Installation Monitoring Report

Date: June 19, 2025

Project	NW 2050 Cypress Point	Job Number	24064	RGC Number	53216		
Address	7511, 7531, 7651 Minoru Boulevard	Inspector	Matthew	Report Number	17		
	Richmond, B.C.	Weather	Cloud / 22°C	Time	1:00pm		
Contractor	Flynn Canada Ltd.	Crew Size	21	Red Seal	5	Apprentices	12

17.6 **Building C**

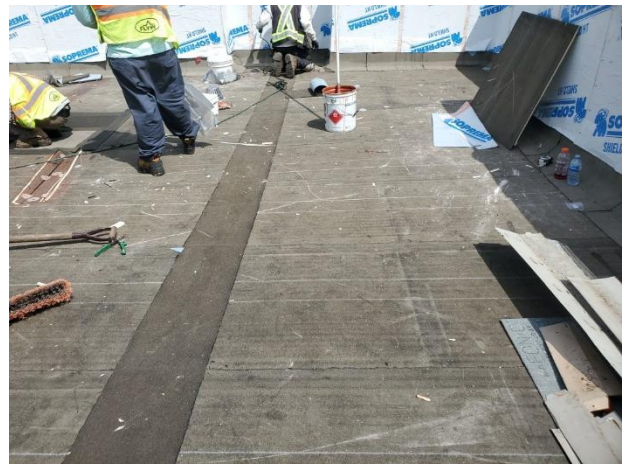
A HT SA membrane is adhered to densdeck prime on the walls with an Elastocol stick adhesive primer.

17.9 **Building C**

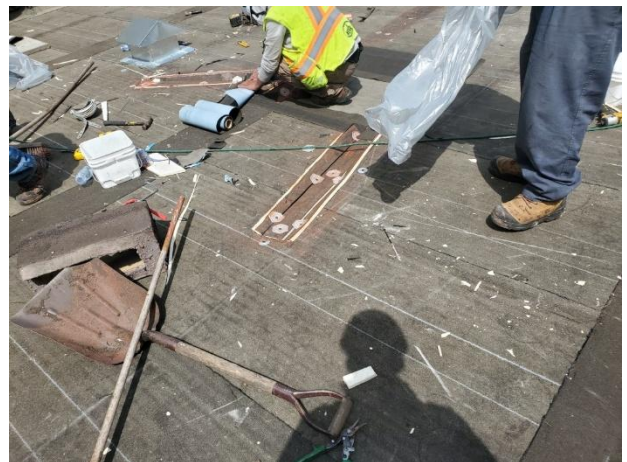
Noted oversized gaps at overlay board joints to be corrected. Foreman was directed to carry out repairs.
